Access Compliance Report

Public Rights-of-Way

(Curb Ramps)

Intersection ID: N/A	Main Street: MILLENNIUM_AV	Cross Street: ANSLEY_GARDEN_DR	Location: NW
ADA ID: 91433052C58E	Ramp Type: Perp	Initial Pass/Fail: Fail	Overall Compliance: No
Severity Score: 12.5			
Codes/Mitigation Info/Possible Solution		Field Measurements/Component Compliance

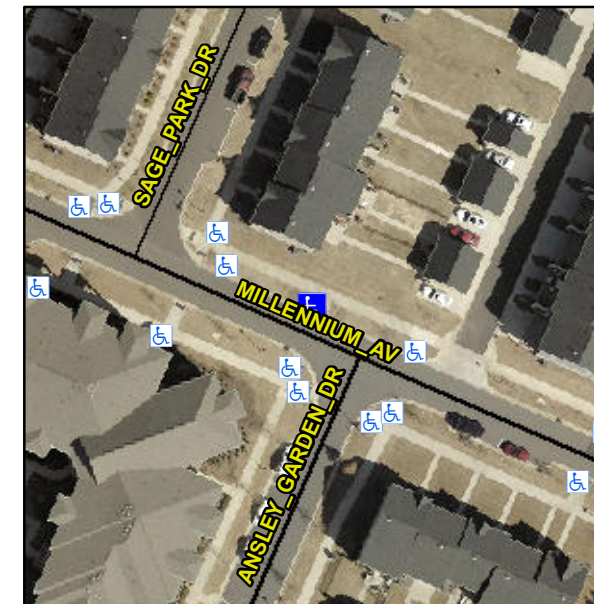
Compliance	Description	Data	Compliance	Description	Data
N/A	Ramp Length (in)	87.0	No	Ramp Slope (%)	9.0
Yes	Ramp Width (in)	70.0	Yes	Ramp XSlope (%)	0.2
N/A	Flare Type LT	N/A	N/A	Flare Type RT	N/A
N/A	Flare Slope LT (%)	N/A	N/A	Flare Slope RT (%)	N/A
N/A	Flare Traversable LT?	N/A	N/A	Flare Traversable RT?	N/A
N/A	Landing Length (in)	N/A	N/A	DWS Provided?	N/A
N/A	Landing Width (in)	N/A	N/A	DWS Contrast?	N/A
N/A	Landing Slope (%)	N/A	N/A	DWS Length (in)	N/A
N/A	Landing X Slope (%)	N/A	N/A	DWS Full Width?	N/A
N/A	Landing Curb? (Y/N)	N/A	N/A	DWS Offset (in)	N/A
N/A	Shared Landing?	N/A			
N/A	Gutter Ponding?	N/A	N/A	Gutter Slope (%)	N/A
N/A	Gutter Lip Ht (in)	N/A	N/A	Gutter X Slope (%)	N/A
N/A	Painted X Walk1?	No	N/A	Painted X Walk2?	N/A
	X Walk 1 Direction	To SW		X Walk 2 Direction	N/A
N/A	X Walk 1 Width (in)	N/A	N/A	X Walk 2 Width (in)	N/A
	X Walk 1 Slope (%)	3.2		X Walk 2 Slope (%)	N/A
	X Walk 1 X Slope (%)	1.2		X Walk 2 X Slope (%)	N/A

Remove & Replace Entire Ramp.

R304.2.2
